# CITY OF ALBUQUERQUE

**RE: Montoya Street Townhomes (File: H12D019A)**  
**Tracts A1 and A2 Lands of David Maciel**  
**Montoya St NW between Floral Rd and I-40**  
**Grading Plan and Drainage Report**  
**Engineer's Stamp Date – 10/15/15**

Based upon the information provided in your submittal received 10-15-15, the above referenced Grading Plan and Drainage Report cannot be approved for Preliminary Plat, Final Plat and Grading Permit until the following comments are addressed.

FLAT GRADING SCHEME

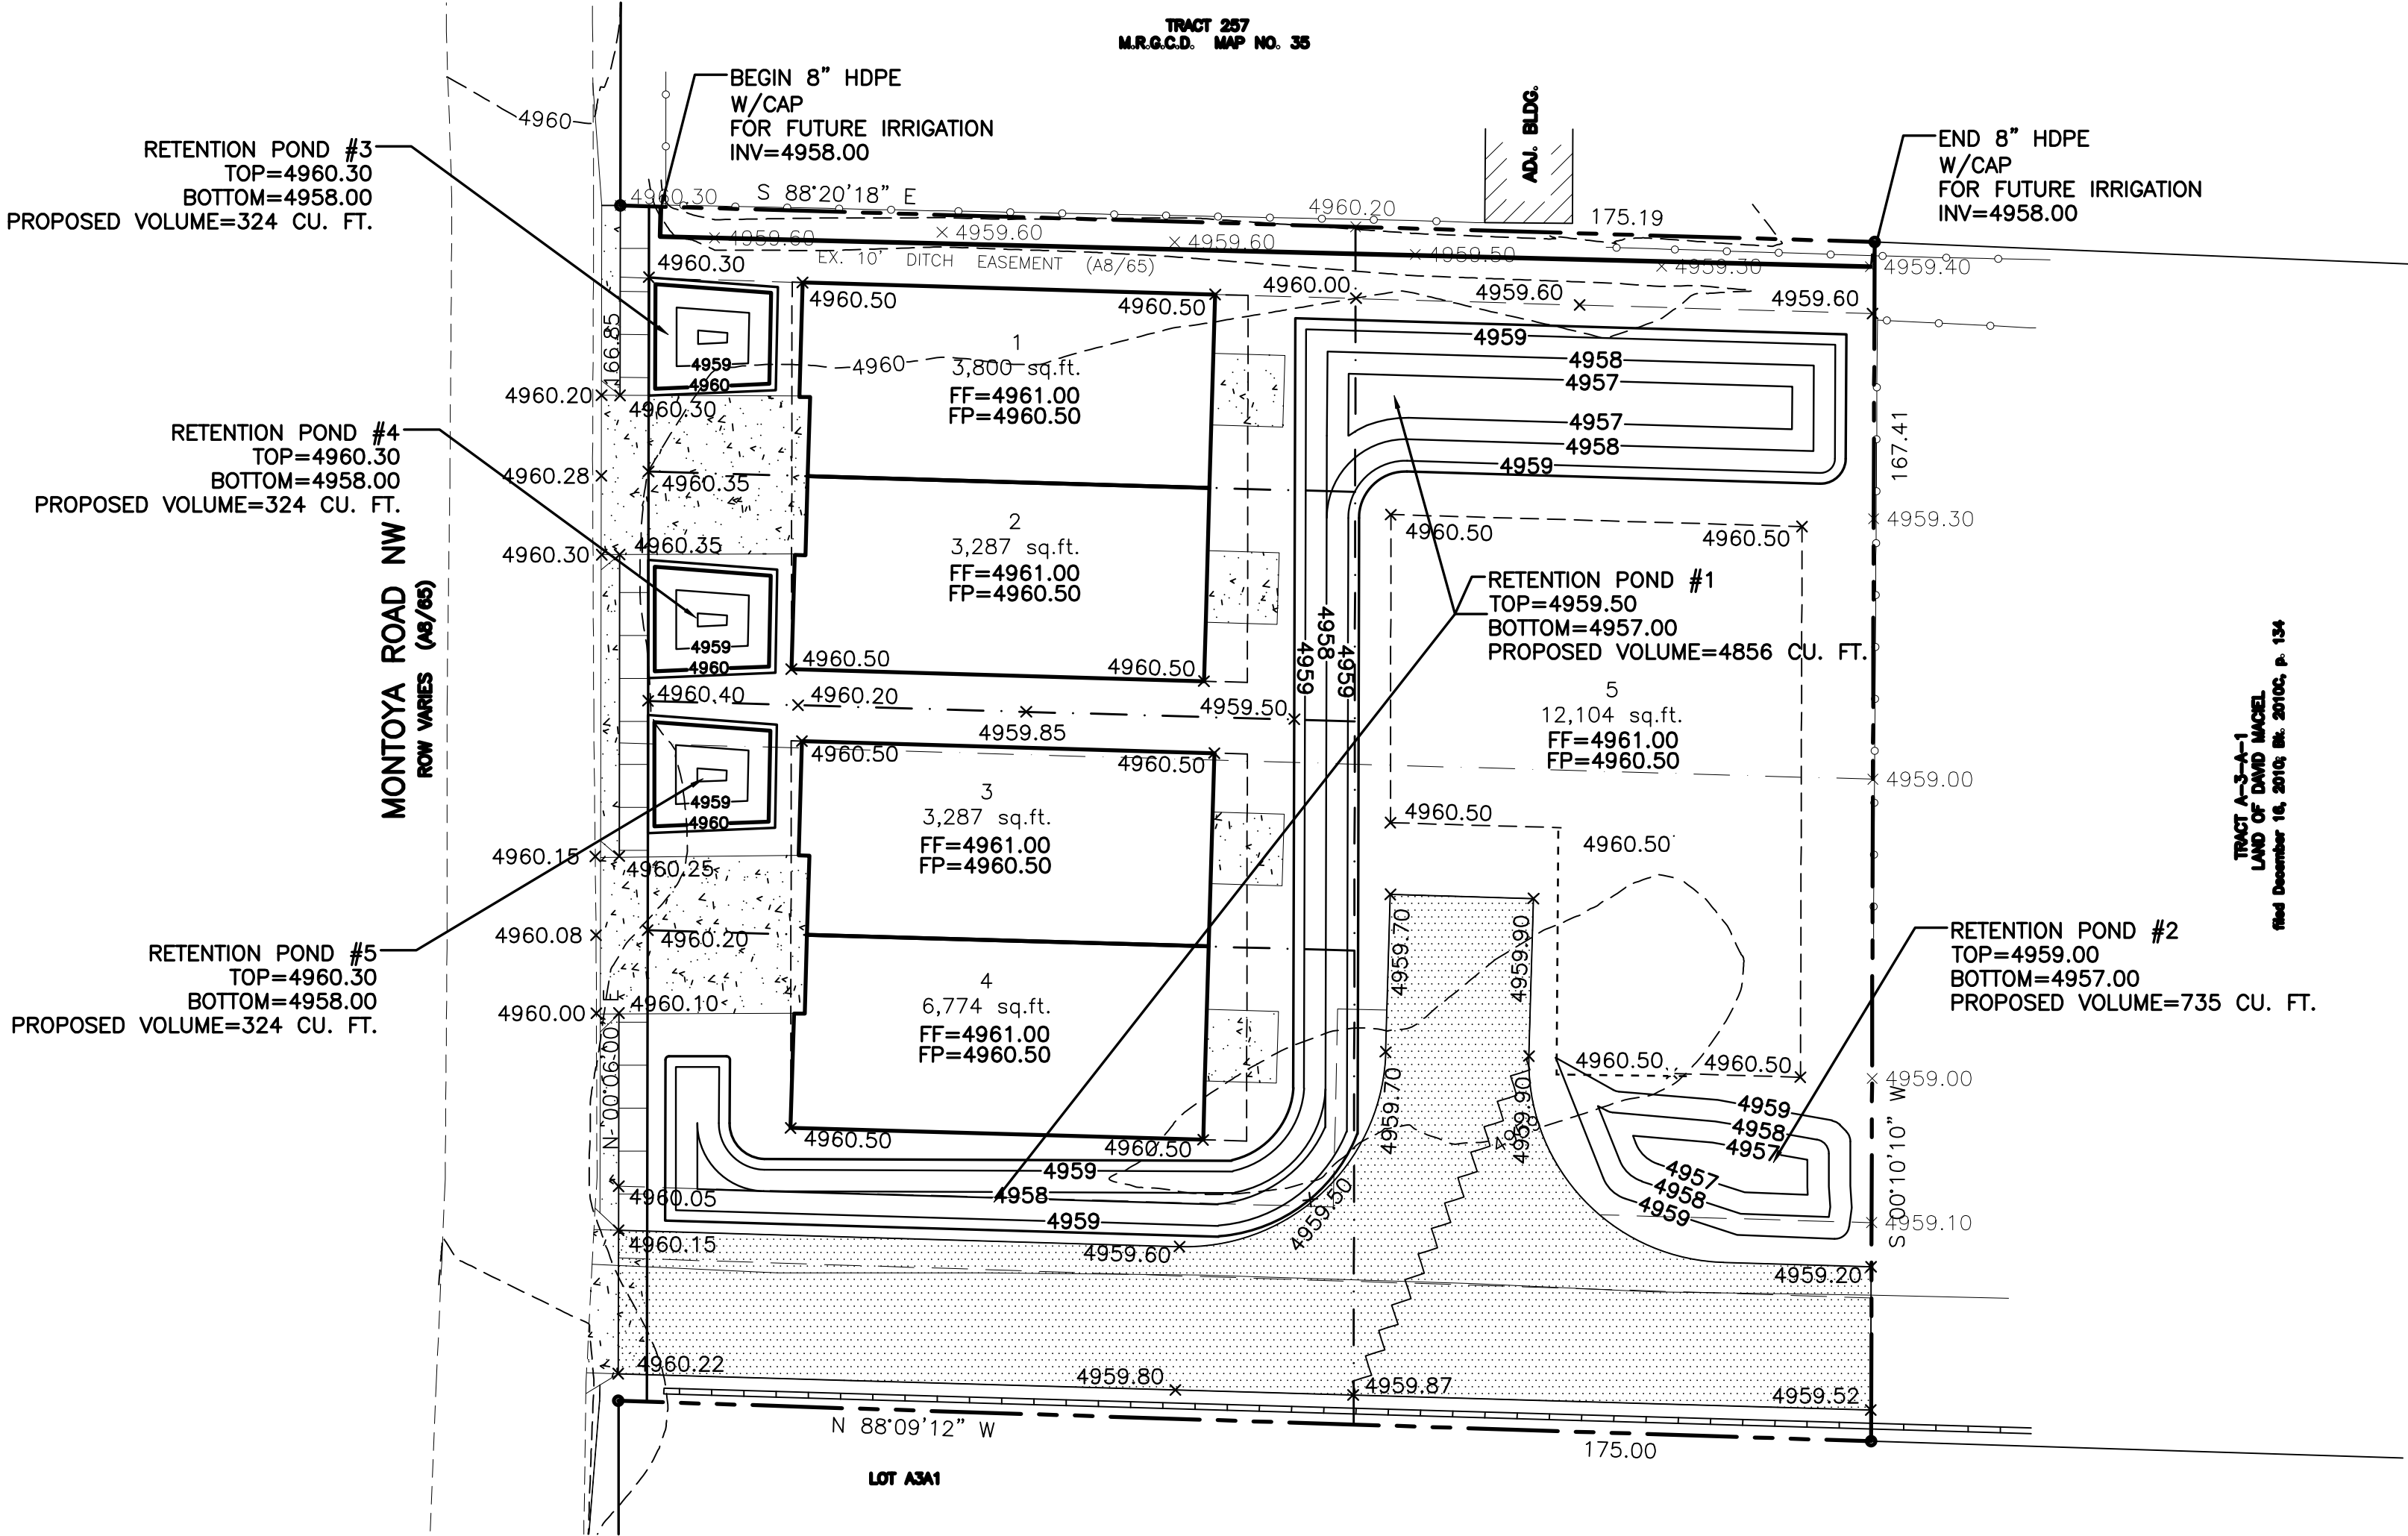
- Provide drainage flow areas to better identify overall site drainage patterns.
- Provide roof flow direction and outfall locations.
- Clearly identify and define property lines.

- Clearly identify the location and limits of the 10 ft Ditch Easement located on the north property line.
- The Drainage Report indicates flows from a storm event exceeding the 100-yr, 6 hr storm event will discharge to Montoya Street. Per the spot elevations identified on the Grading Plan, it appears flows will be directed east away from Montoya Street. Show on the Grading Plan how this will be achieved.

- A scale check on the area for townhomes 1-5 appears as though the area provided is incorrect. Re-check the areas to ensure the information is correct.
